SECTION 96 SUBMISSION

DEE WHY RSL CLUB - 932 PITTWATER ROAD
STAGE 5 CLUB EXTENSION

THIS PLAN TO BE READ IN CONJUNCTION WITH
MOD2018/0119
NORTHERN BEACHES COUNCIL

PROJECT:
STAGE 5 - CLUB EXTENSION
PHASE 2 WORKS - SOUTHERN
CARPARK & ENCLOSURE

DRAWING TITLE:
SHADOW DIAGRAM - 21 JUNE

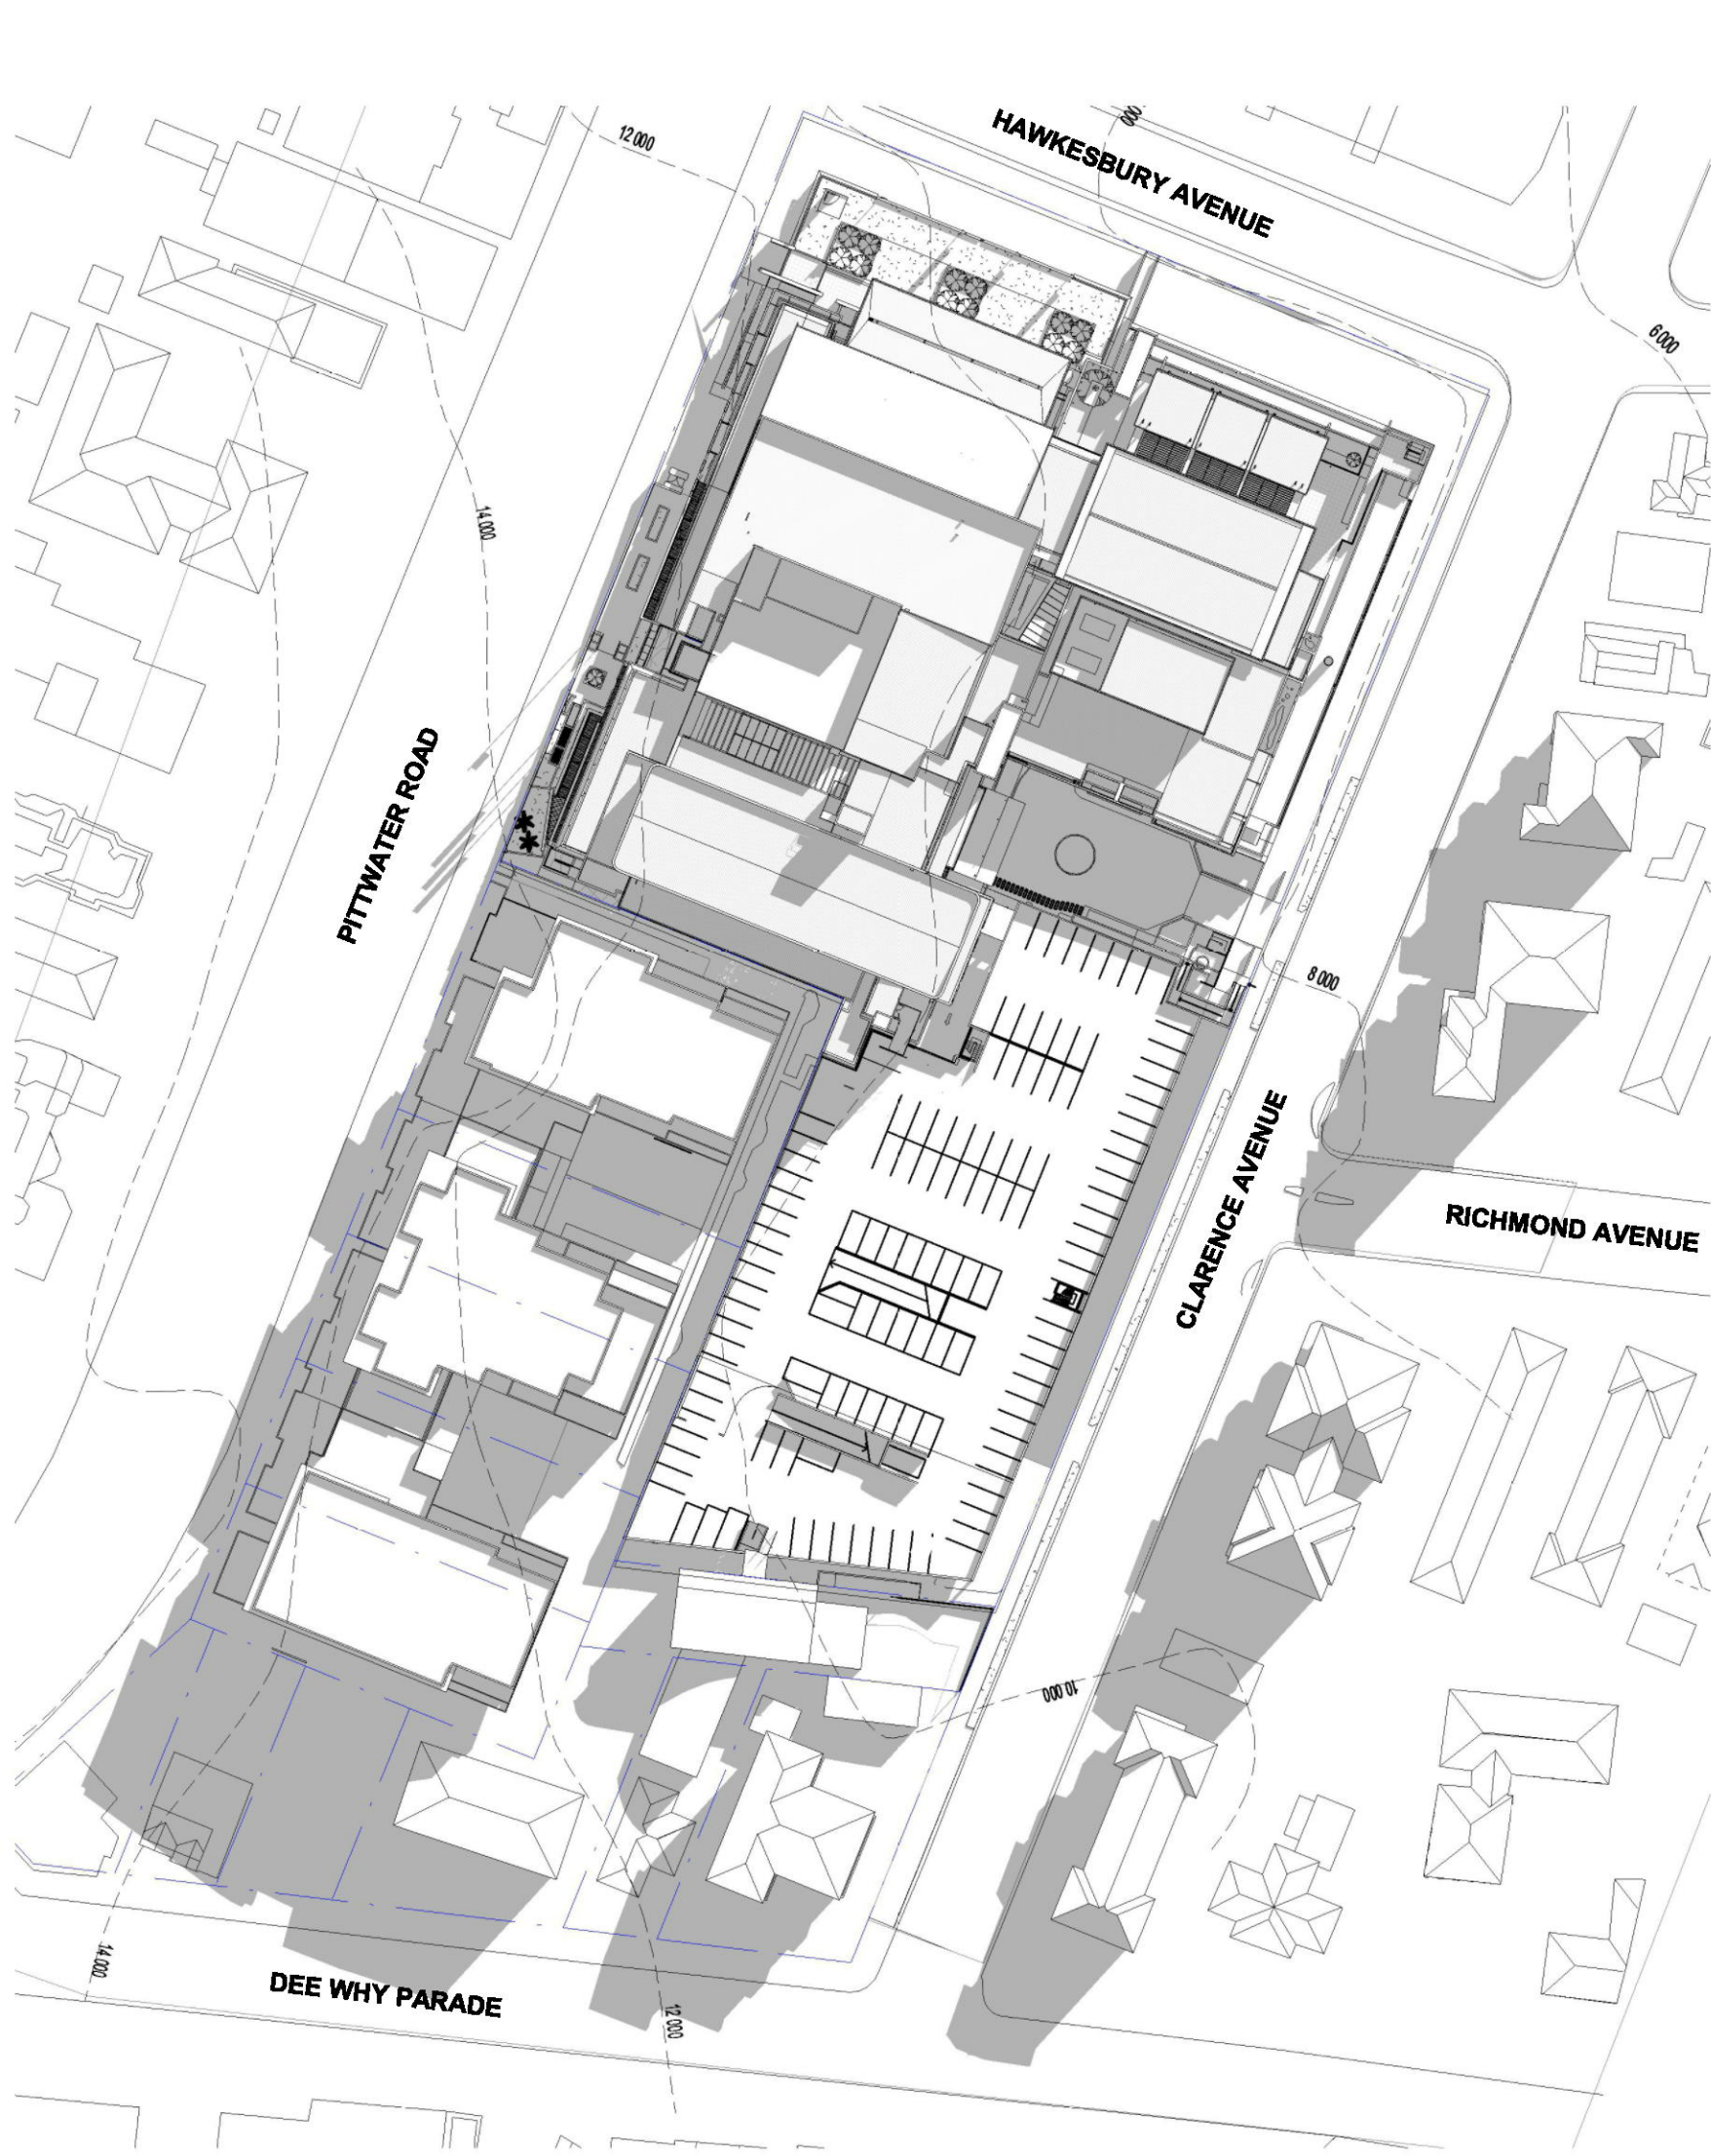
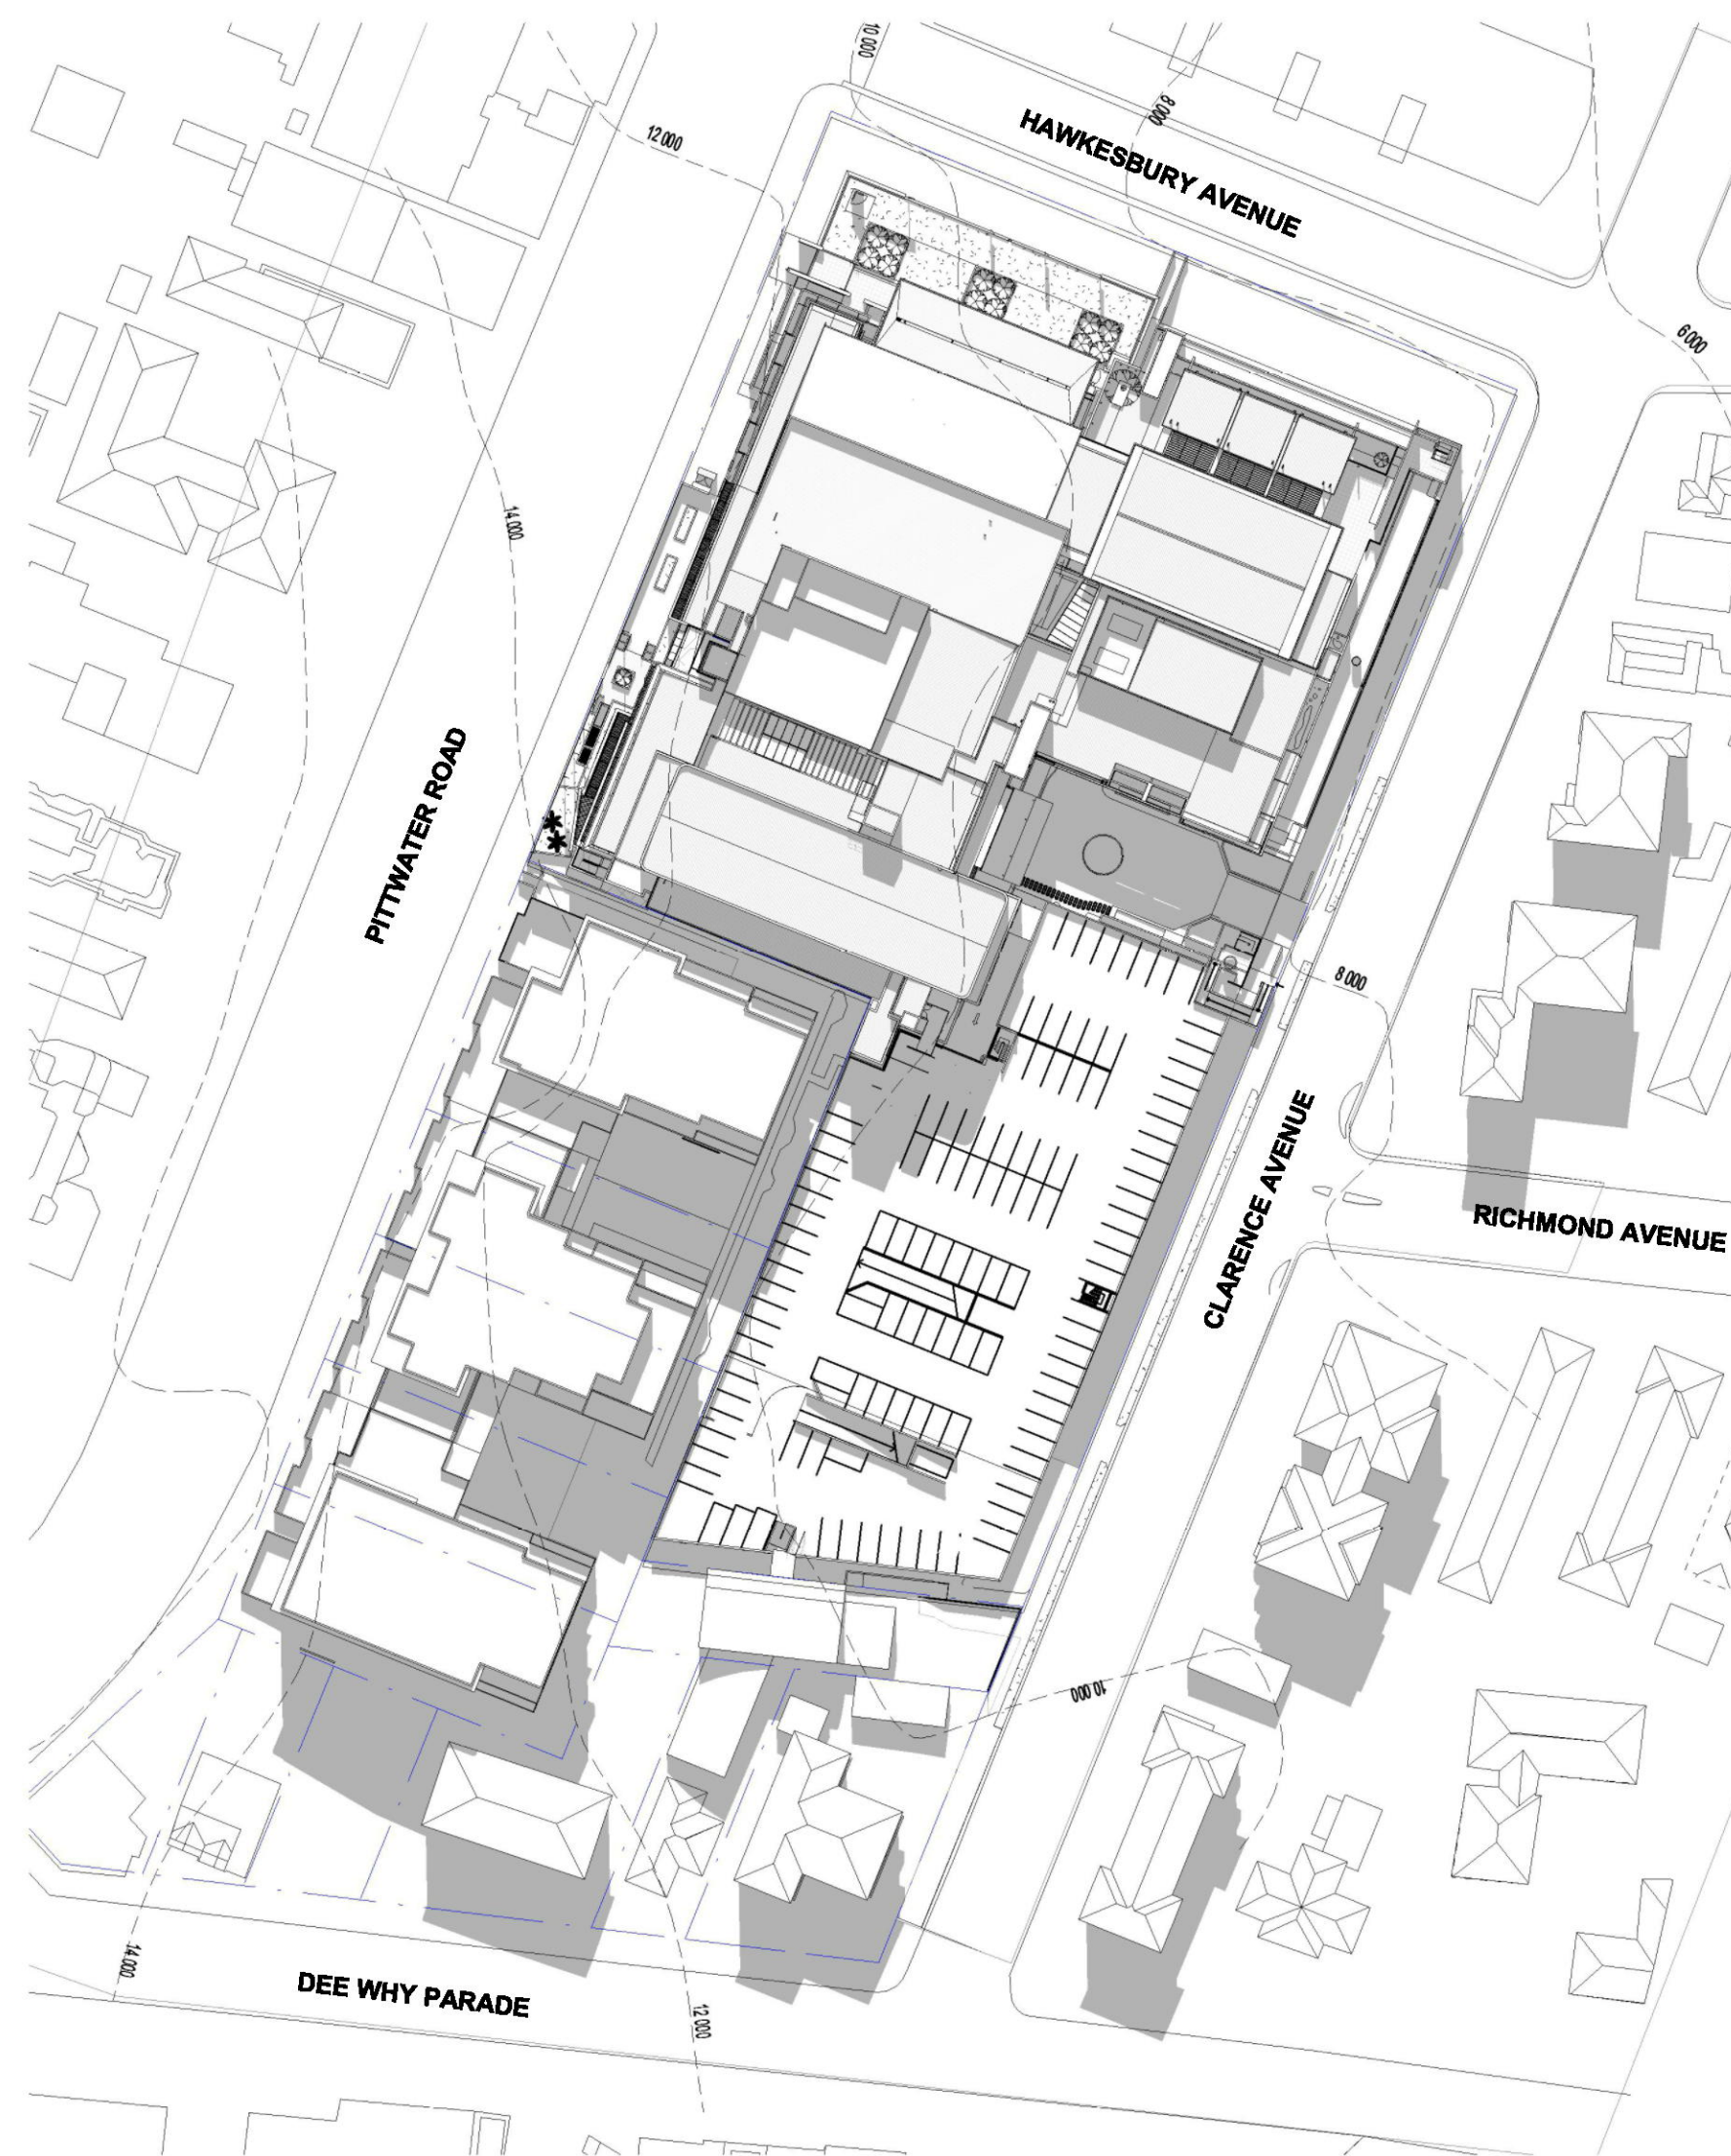
- SHADOW CAST BASED ON SECTION 96 MODIFICATIONS, REDUCED IMPACT
- SHADOW CAST ONTO SURROUNDING BY PROPOSED DEVELOPMENT AS PER ORIGINAL DA 2017/0244
